TOLEDO - LUCAS COUNTY PLAN COMMISSIONS

REF: SUP-5008-23

SUBJECT: Special Use Permit for a Community Recreation-Active at 2053 N 14th St.

SCALE: AS SHOWN
SHEET TITLE
SITE DIMENSION
PLAN (NORTH)

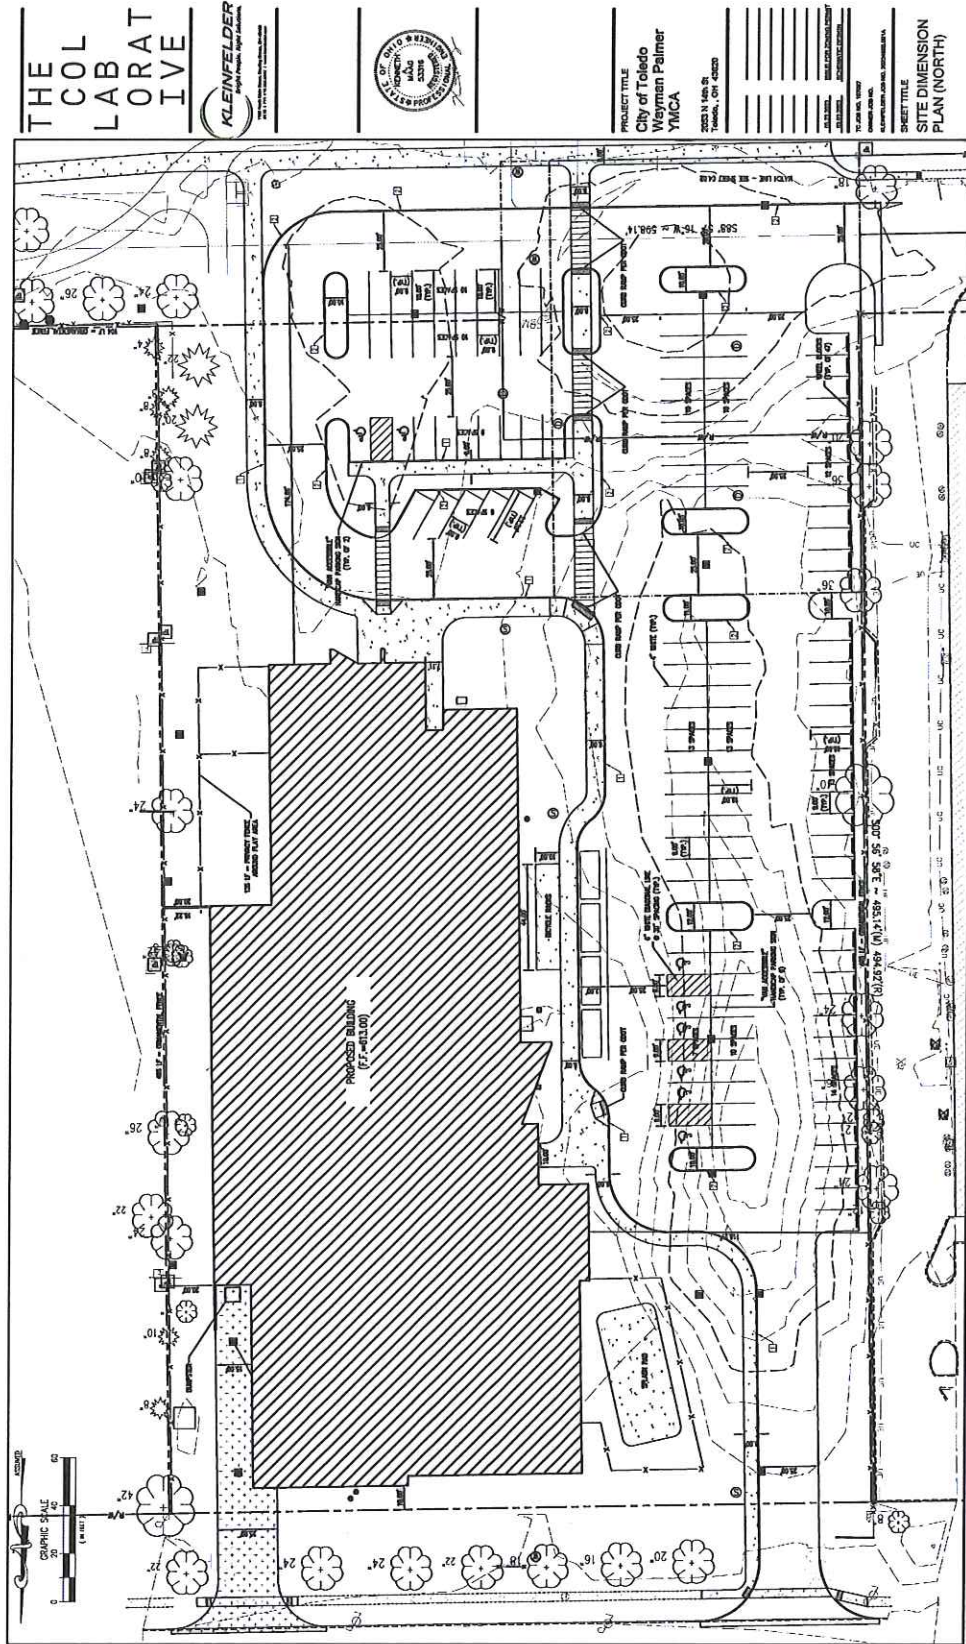
Additionally, any playground, sport court, or other active recreation are must be set back at least fifty (50) feet from any RS or RD district. The site plan proposes an outdoor play-area just over sixteen (16) feet from the property line abutting an RS district. A waiver shall be required, however because this space is intended for supervised care during operating hours and not public use, staff supports this waiver.

The new layout moves parking to the northern portion of the site to serve the new YMCA building. Parking enters from the vacated section of Wayman Palmer Court (Companion Case V-280-23), and introduces a second drive-way from Bancroft. The new parking area provides one-hundred and thirty-seven (137) parking spaces. Pursuant to TMC§1107.0600 – Off-Street Parking Schedule “D”, Community Recreation facilities have a wide variety of parking demand characteristics making it difficult to specify a single off-street parking standard. Therefore, Schedule “D” parking allows the minimum off-street parking requirements to be established via a

parking study provided by the applicant. The applicant shall be required to submit justification for the proposed one-hundred and thirty-seven (137) spaces.

A portion of the total number of required off-street parking spaces must be specifically designated, located, and reserved for use by persons with physical disabilities. According to the table in TMC§1107.1701 – *Number of Required Parking Spaces for Persons with Disabilities*, the applicant is required to provide at least one (1) van accessible space with an eight-foot (8') drive aisle and four (4) car accessible spaces with five-foot (5') drive aisles for persons with physical disabilities. The parking area provides eight (8) van accessible areas, and is acceptable as depicted. Per comments from the Division of Transportation, accessible spaces shall be moved closer to the primary accessible entrance.

Bicycle parking is required pursuant to Off-Street Parking Schedule "A" (TMC§1107.0300). A minimum of one (1) bicycle space shall be provided per ten (10) automobile parking spaces. The proposed plan requires fourteen (14) bicycle parking spaces. A bicycle rack area is shown to the west of the building. Hardware and spacing of bicycle parking spaces is not indicated and shall be required on a revised site plan. Based on the forty-four (44) foot pad, it is estimated twenty-two (22) bicycle spaces can fit in the area. The applicant is strongly encouraged to locate a set of bike racks on the southern edge of the parking lot as well, to accommodate park usage.

A masonry trash enclosure with a louvered gate is proposed on the eastern portion of the parking area. Said dumpster location is not acceptable due to its close proximity to residential parcels per TMC§1108.0203G5. The dumpster shall need to be relocated nearer to the interior of the site or the commercial uses to the west.

38. Per TMC§1107.0400, Off-Street Parking Schedule “A” requires one (1) bicycle parking slot per ten (10) parking spaces. **Not acceptable as depicted, exact rack placement shall be specified, location and dimensions acceptable.**

41. All outdoor play areas must be a minimum of fifty (50) feet from adjacent residential uses. **A waiver shall be obtained or the play area shown to the east of the building shall be relocated.**

42. A minimum twenty-five-foot setback from the right-of-way shall be maintained. **A waiver shall be obtained or the building shall be relocated. Relocation may require an amendment of this Special Use Permit.**

44. The location of the dumpster is **not acceptable as depicted**. The six-foot masonry enclosure is acceptable, however shall be moved to the interior of the site or nearer the commercial uses and away from the residential district to the east.

Approve of a waiver to allow ten-foot (10') setback from Bancroft in order to help establish a street-wall in an older neighborhood, and create a welcoming entrance to the facility and park.

Approve of a waiver to allow a setback less than fifty-feet from RS or RD districts for the outdoor play area shown on the plan. The proposed play area is screened with a separate gate, and not intended for public use outside of supervised hours.

SHEET TITLE
SITE
LANDSCAPE
PLAN

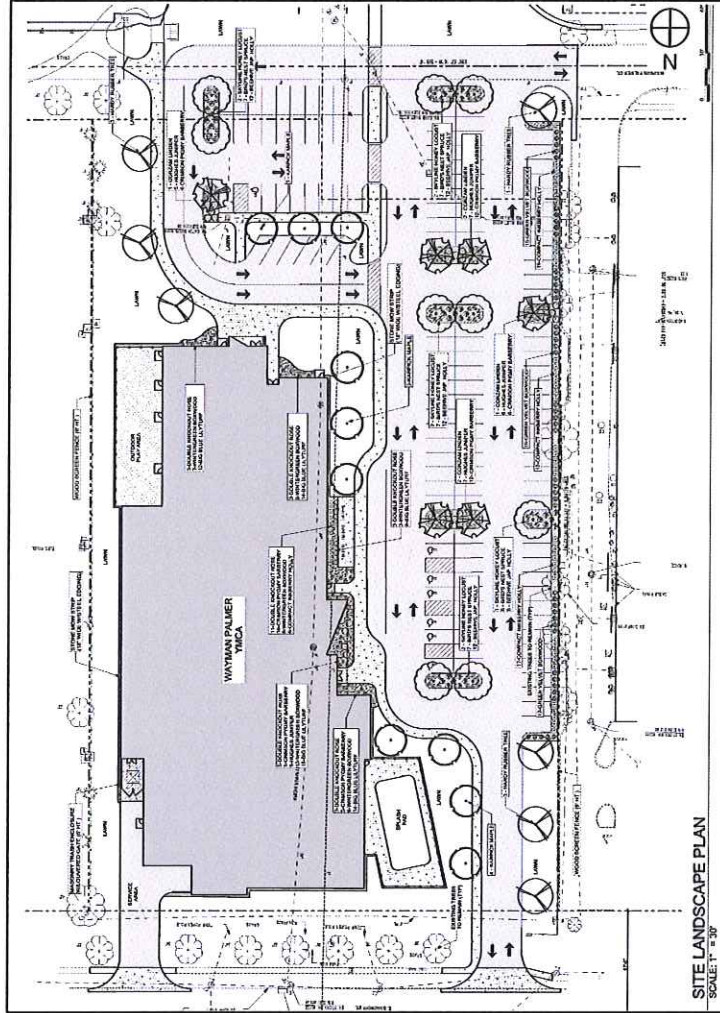
Per **TMC§1108.0202 – Frontage Greenbelts**, sites are required to provide a minimum thirty-foot (30') wide frontage greenbelt and contain at least one (1) tree for every thirty feet (30') of frontage. Staff support for the waiver of building setback extends to support for the waiver of the thirty-foot (30') greenbelt. In lieu, a ten-foot (10') greenbelt is provided along Bancroft. Landscaping shown in the right-of-way shall be preserved per the provided landscaping plan. However, additional plantings shall be required within the properties boundaries. Nine (9) trees shall be provided within the ten (10) to thirty (30) feet of the property line along Bancroft. Landscaping in the southern portion of the site shall be reviewed in full at the time of park redevelopment. Where facing the roadway, shrubs are required along all parking lots. A solid row of ever-green shrubs shall be required along the northern sidewalk adjacent to the splash pad. A continuous line of shrubs shall also be required to the east of the parking lot where the parking area is visible from abutting residential properties.

Within parking lots two (2) canopy trees are required per each ten (10) parking spaces. Additionally, six (6) shrubs are required per ten (10) parking spaces. Trees and shrubs do not have to be equally spaced, but may be grouped. Twenty-seven (27) trees, and eighty-four (84) shrubs are required. Twenty (20) interior trees are provided, an additional seven (7) trees shall be required. The total one-hundred and sixty-one (161) provided interior shrubs are acceptable as depicted. Due to the size of the building, forty-three (43) trees are required per TMC§1108.0205. The applicant intends to use three (3) trees greater than 36-inch caliper for a total of thirty (30) tree credits, as well as six (6) trees worth one credit a piece. Combined with proposed plantings the total number of trees. Given the adjacent park, and ample plantings provided, the reduction is acceptable as depicted. Foundation planting is required along all portions of the building visible from the roadway. Foundation plantings shall be required along the front of the building facing Bancroft. A six-foot privacy fence is proposed adjacent to the neighboring residential uses, and is acceptable as depicted. In order to assist in screening the building a type A landscape buffer per TMC§1108.0203E shall be required including one fifteen (15) shrubs and four (4) trees per one-hundred linear feet adjacent to the residentially zoned parcels to the east.

- a. The minimized ten-foot (10') greenbelt is acceptable as depicted in width, however one (1) tree per thirty (30) feet of frontage is required. Nine (9) trees shall be required within thirty (30) feet of the property line adjacent to Bancroft. Trees in the right-of-way shall not be credited. **Not acceptable as depicted**.

- b. Perimeter landscaping must be installed along any parking lot area adjacent to a street, place, or driveway, or which is visible from an immediately adjacent property, and must include a continuous shrub row with a minimum height eighteen inches (18"). **Not acceptable as depicted: Additional shrubs required along the northern portion of the parking lot facing Bancroft and eastern portion facing residential.**

- e. Foundation plantings shall be provided along the northern and eastern elevations. **Not acceptable as depicted.**
- f. Screening shall be provided between the structure and residences to the east. **Acceptable as depicted.**

Approve of a waiver to allow ten-foot (10') greenbelt from Bancroft in order to help establish a street-wall in an older neighborhood, and create a welcoming entrance to the facility and park.
